# Access Compliance Report

## Public Rights-of-Way

### (Curb Ramps)

Intersection ID: 28584	Main Street: FALCONCREST_DR	Cross Street: HIGHLAND_CREEK_PY	Location: E
ADA ID: 956612CA331F	Ramp Type: PerpDiag	Initial Pass/Fail: Fail	Overall Compliance: No
		Severity Score: 12.5

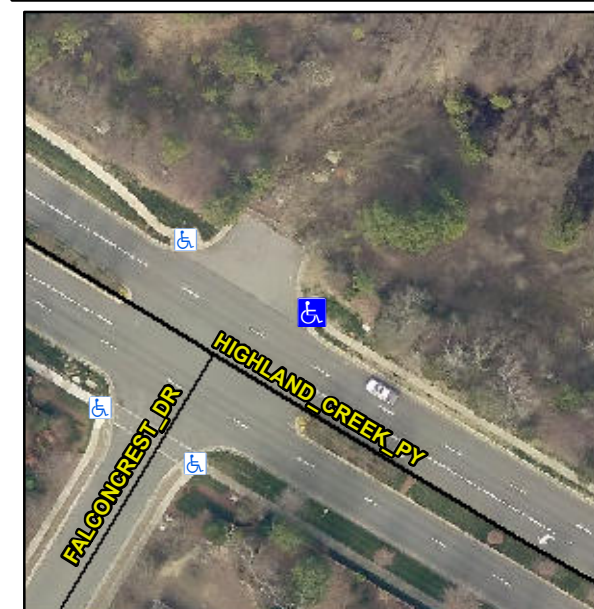
**Not Found, R304.2.2**

Compliance	Description	Data	Compliance	Description	Data
N/A	Ramp Length (in)	95.0	No	Ramp Slope (%)	8.7
Yes	Ramp Width (in)	51.0	Yes	Ramp XSlope (%)	1.9
N/A	Flare Type LT	N/A	N/A	Flare Type RT	N/A
N/A	Flare Slope LT (%)	N/A	N/A	Flare Slope RT (%)	N/A
N/A	Flare Traversable LT?	N/A	N/A	Flare Traversable RT?	N/A
N/A	Landing Length (in)	N/A	N/A	DWS Provided?	N/A
N/A	Landing Width (in)	N/A	N/A	DWS Contrast?	N/A
N/A	Landing Slope (%)	N/A	N/A	DWS Length (in)	N/A
N/A	Landing X Slope (%)	N/A	N/A	DWS Full Width?	N/A
N/A	Landing Curb? (Y/N)	N/A	N/A	DWS Offset (in)	N/A
N/A	Shared Landing?	N/A			
N/A	Gutter Ponding?	N/A	N/A	Gutter Slope (%)	N/A
N/A	Gutter Lip Ht (in)	3.0	N/A	Gutter X Slope (%)	N/A
N/A	Painted X Walk1?	No	N/A	Painted X Walk2?	No
	X Walk 1 Direction	To NW		X Walk 2 Direction	To SW
N/A	X Walk 1 Width (in)	N/A	N/A	X Walk 2 Width (in)	N/A
	X Walk 1 Slope (%)	0.9		X Walk 2 Slope (%)	0.3
	X Walk 1 X Slope (%)	1.2		X Walk 2 X Slope (%)	0.4

**Remove & Replace Curb Ramp With Two New Directional Ramps or Equivalent.**
